Re: Response to comments from the Sustainability Officer

During December 2014 RWDI was retained to assess the wind microclimate around the Proposed 403 Liddell Road Development. On the 30th of January 2015 we received a request to provide a clarification with regard to the wind environment within the on-site amenity spaces and further assessment of the off-site Maygrove Peace Park to the west.

403 Liddell Road - London, UK

**Proposed Development Ground Floor & Terrace Plan Expected
Windiest Season Comfort Levels**

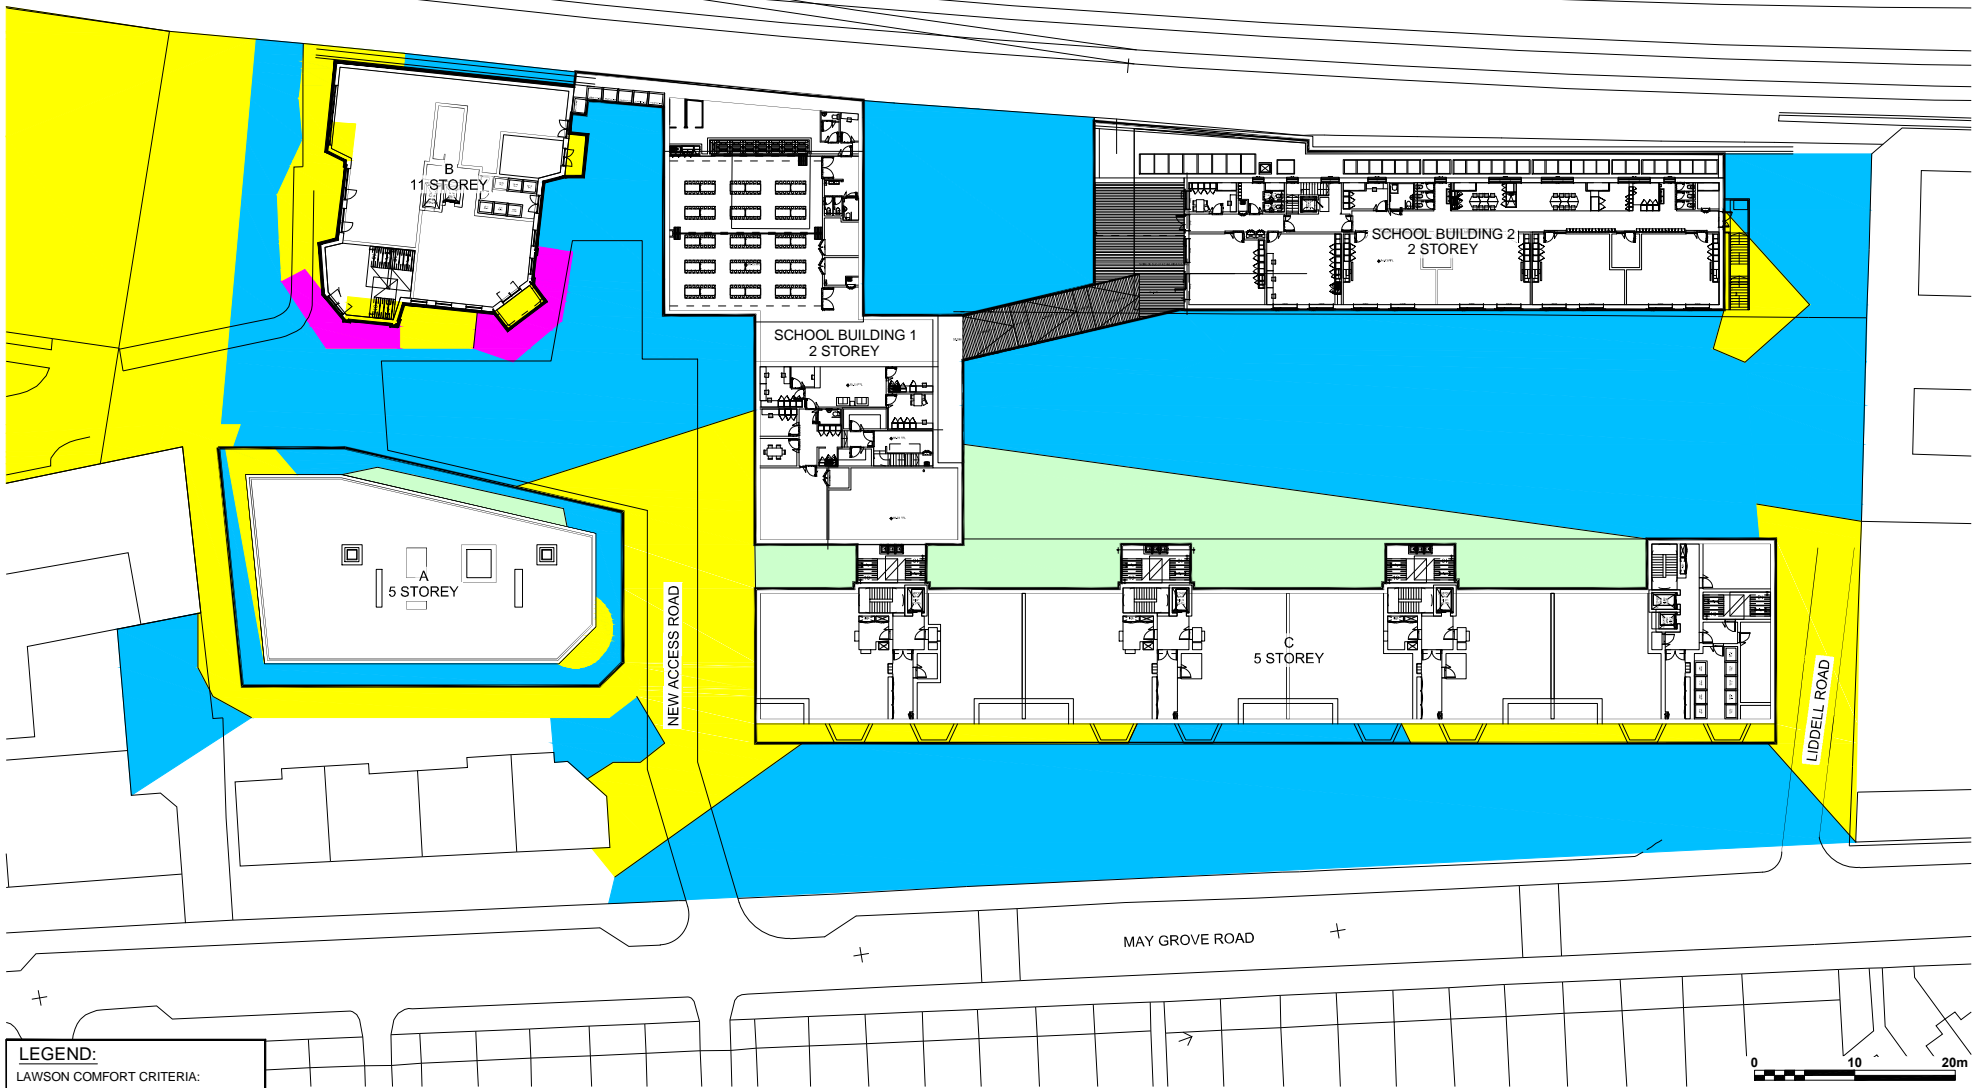
The impact of shading and wind on the adjacent Maygrove Peace Park (western boundary), in particular the MUGA, outdoor gym and area of natural green space has also not been addressed – For example, it's not currently clear whether the tall building is set back enough from the park to avoid shading the wildwood area and the park itself.

- As shown in the wind comfort plots appended, the MUGA space is likely to experience wind conditions suitable for standing/ entrance use during the summer season and leisure walking during the windiest seasons which, considering the sort of activity expected within a games area, is expected to be suitable. These conditions are expected to be the same when the Proposed Development is in place as already exists in the baseline scenario (i.e. no significant effect resulting from the Proposed Development).

- At the outdoor Gym which is situated on the south side of the MUGA, conditions within this space are also expected to be suitable for standing/entrance conditions during the summer and leisure walking during winter. As for the MUGA noted above, conditions within this space are considered to be acceptable for the intended use of the area, due to the higher levels of activity (compared to a typical outdoor seating area) expected within the gym.

Drawn by: KMY Figure: 9

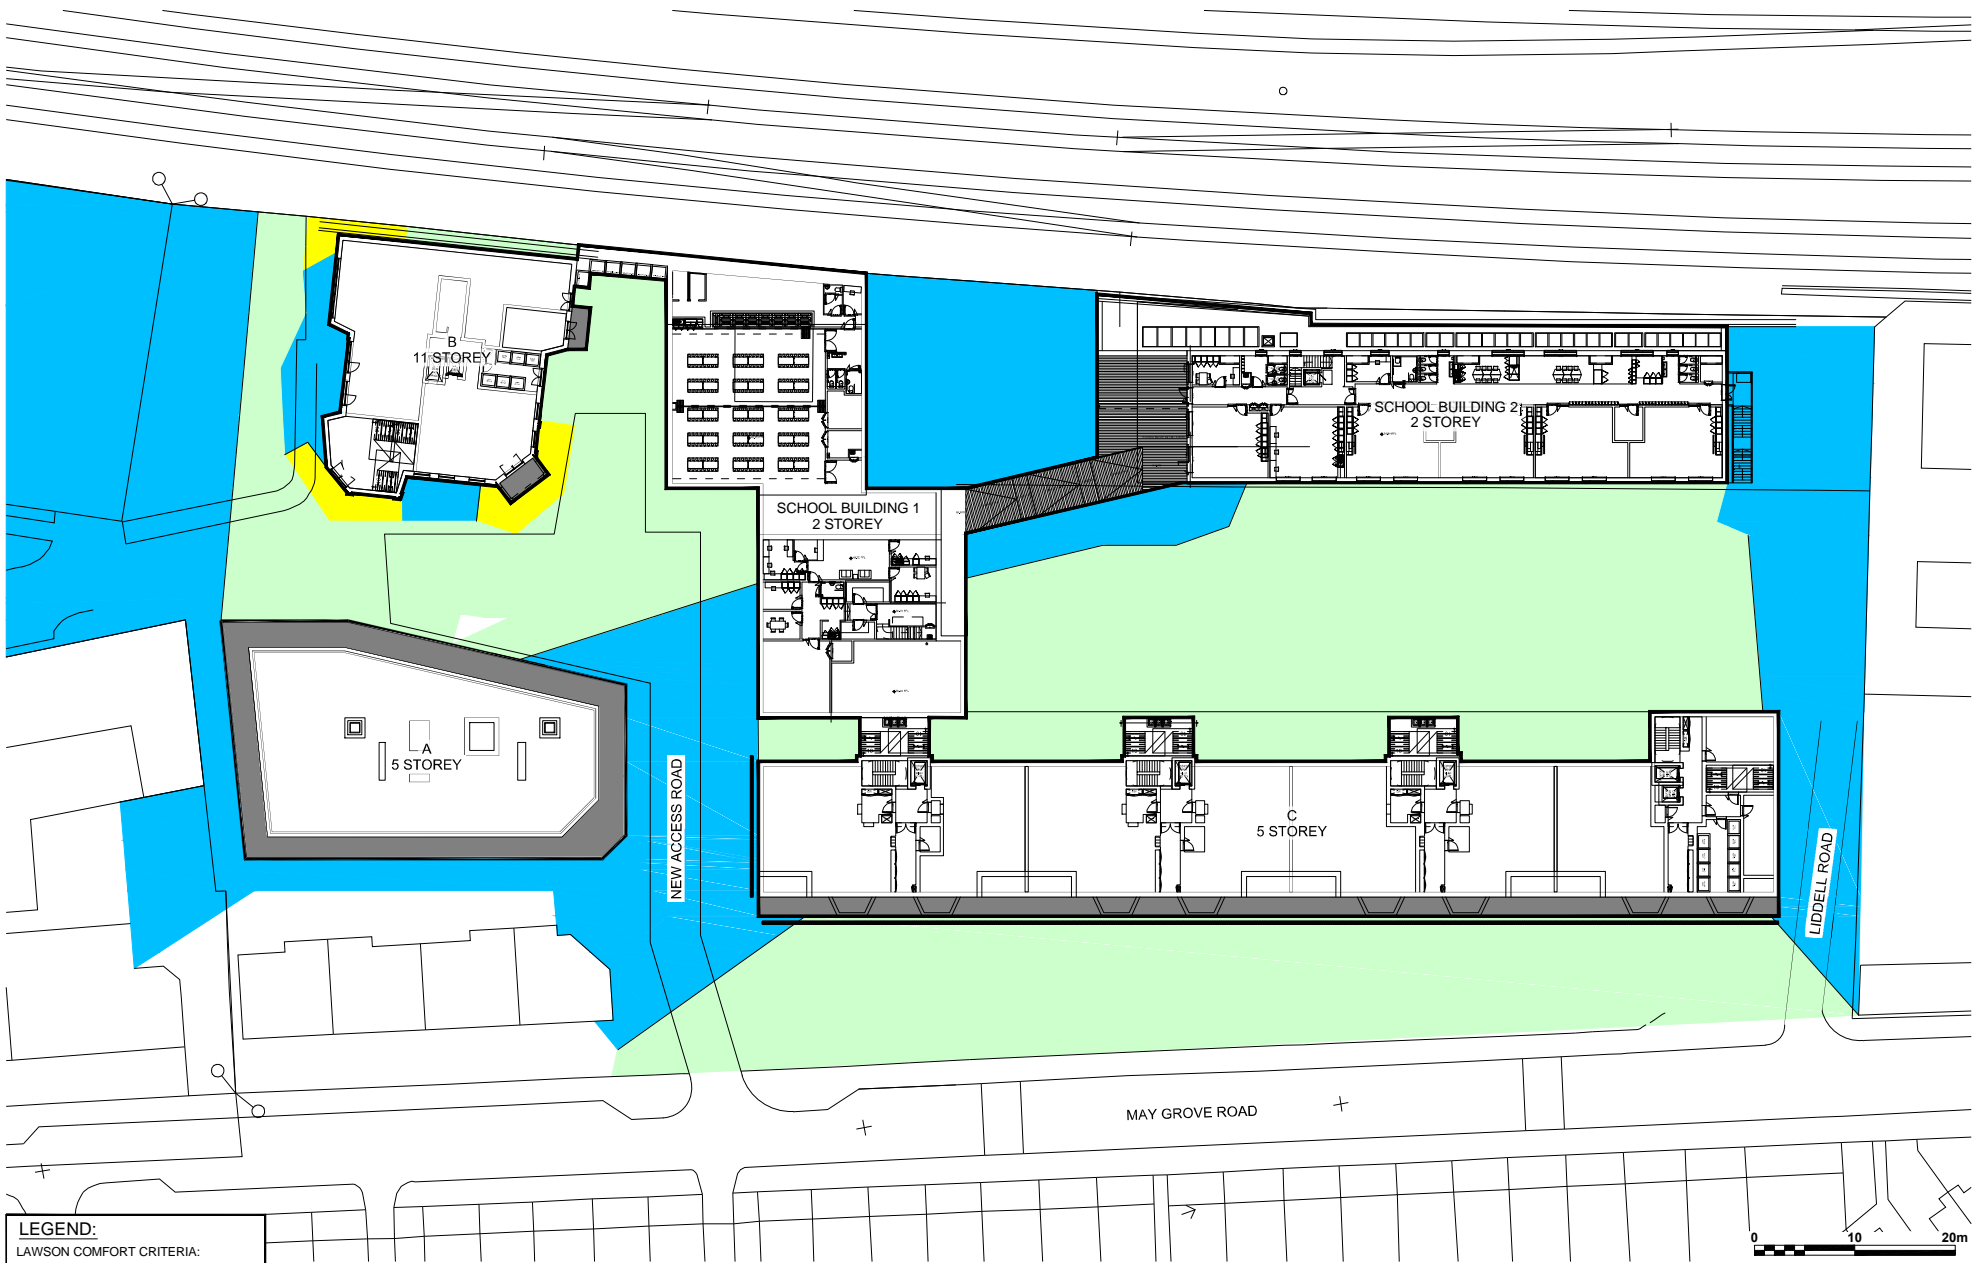
An analysis of wind and shading of the public open spaces was requested at an internal consultation meeting in 2014 to assess the impact of the development on the usability of the proposed public open spaces within Phase 2. A wind study has not been provided and the sunlight, daylight and overshadowing surveys provided with the application do not appear to have considered the impact on the open spaces.

- On-Site amenity spaces are expected to be relatively well sheltered and will be suitable for sitting during the summer season, which is appropriate for an amenity space (see appended Figure 9).
